Index 302 Traffic Separators

COMMENTS AND RESPONSES

BLACK = Industry Review Comments **RED** = Standard Plans Response

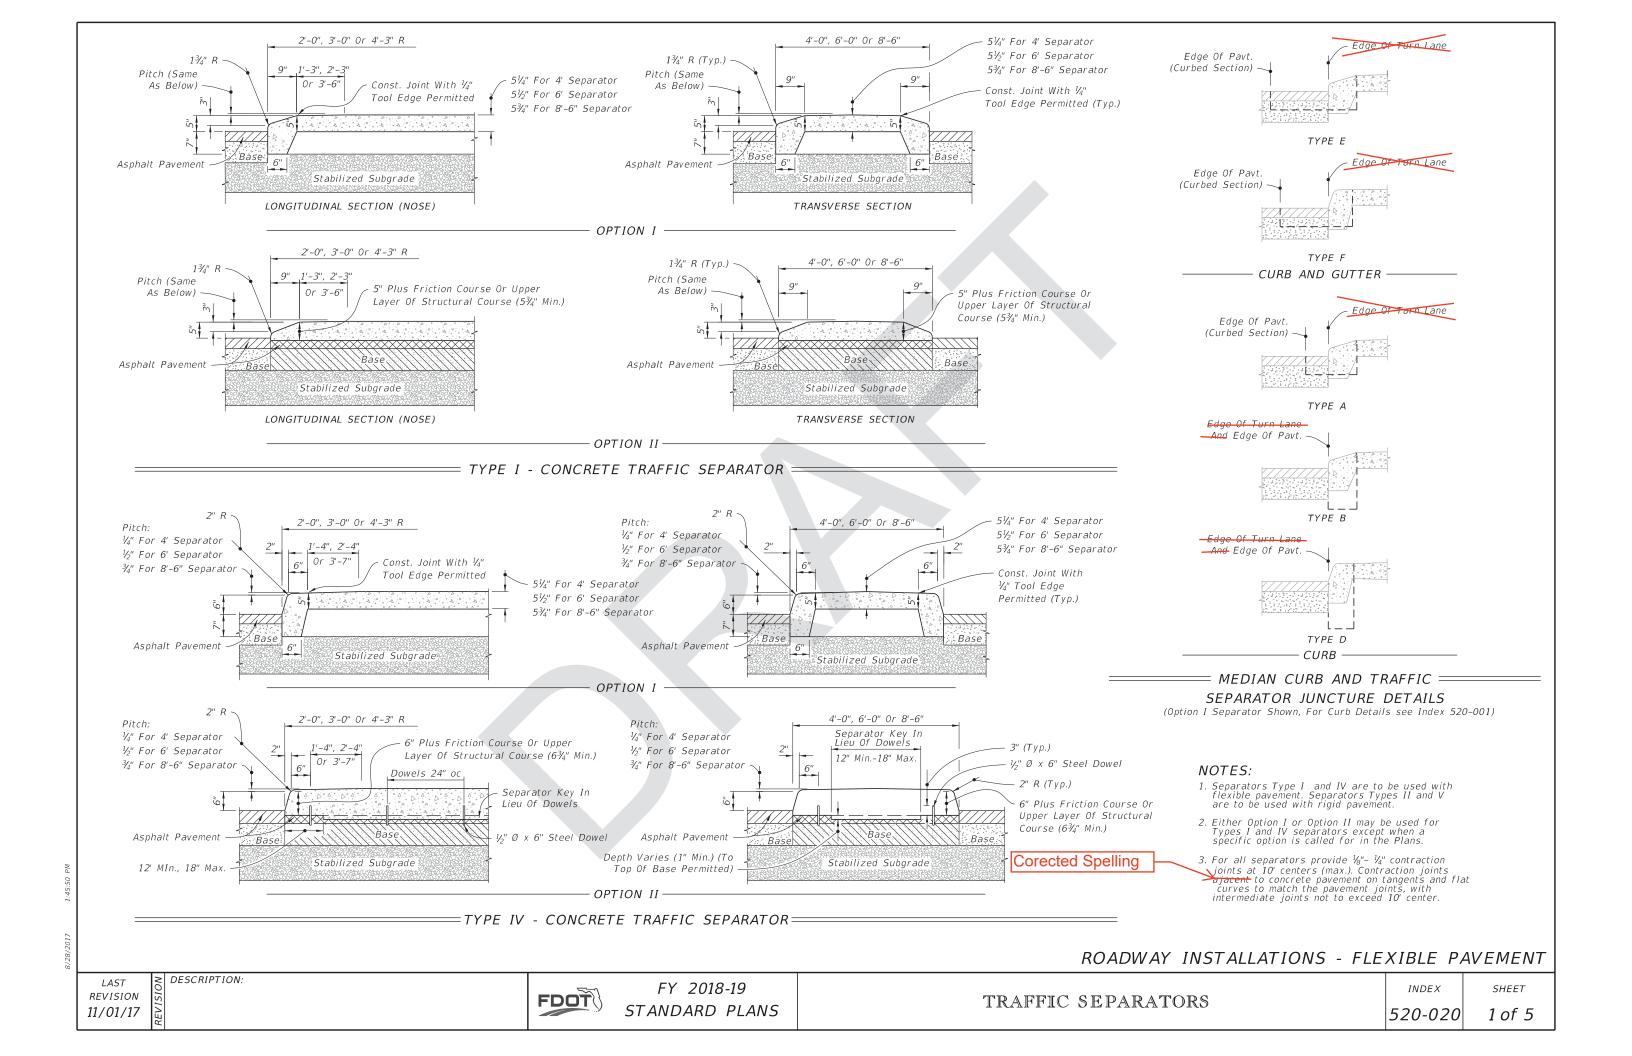
Proposed sheet 5 of 5, NOTES at top right of sheet:

- Concrete
- Reinforcing steel
- Payment
- Traffic Separator Construction

Do not duplicate/conflict with specification Section 520. Notes not needed; modify 520 if minor text changes are necessary.

Agreed. Information will be removed.
